2015/08/12

MVSC-220/260/300/460 Series Pilot Body, Push Button, Rear Cover, Terminal Assy, Coil Nut, and Coil Assy Color Change Notification

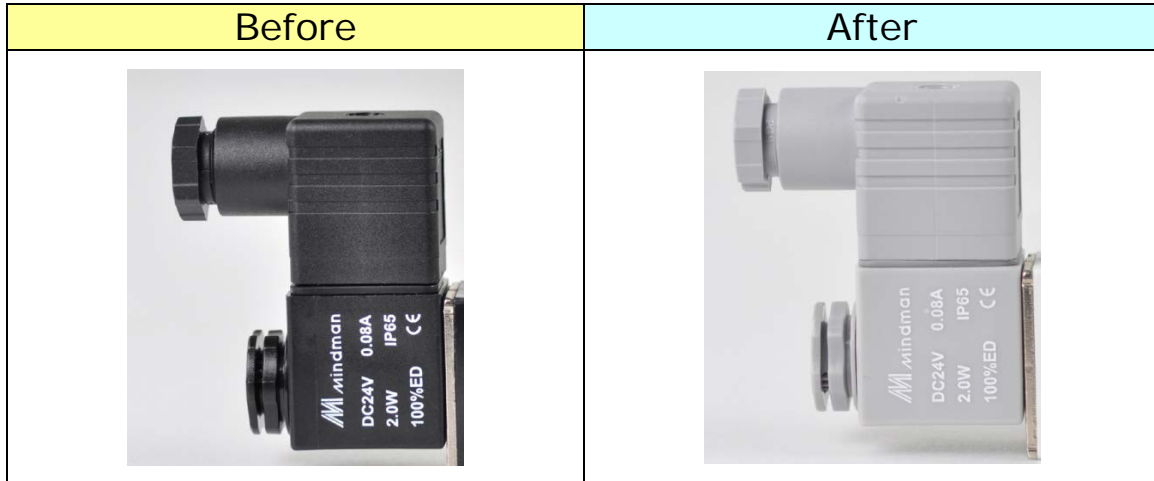
A. Pilot Body: color changes from black to gray cold.

Push Button: color changes from white to sky blue.

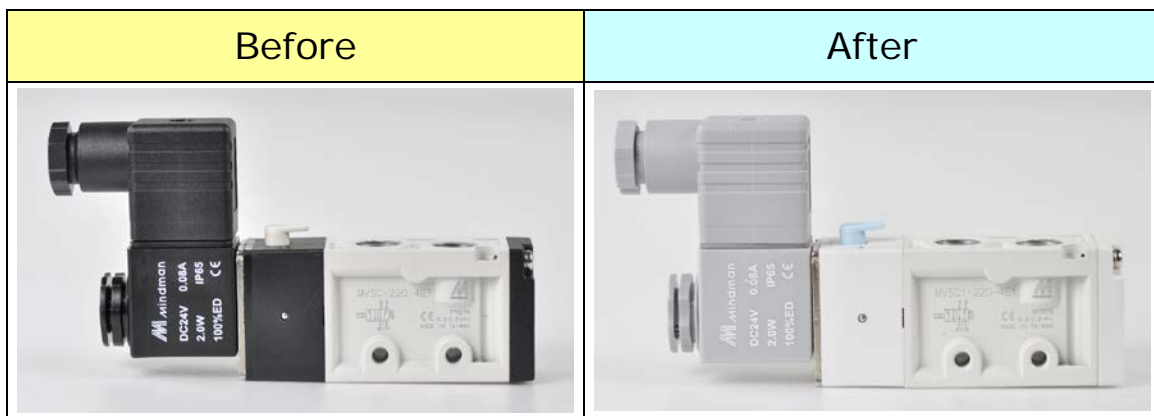
C. Coil Nut、Coil Assy, and Terminal Assy: color changes from black to gray cold.

Notes: Terminal assy with explosion protection type and Coil assy with lead wire type are keeping black in color.
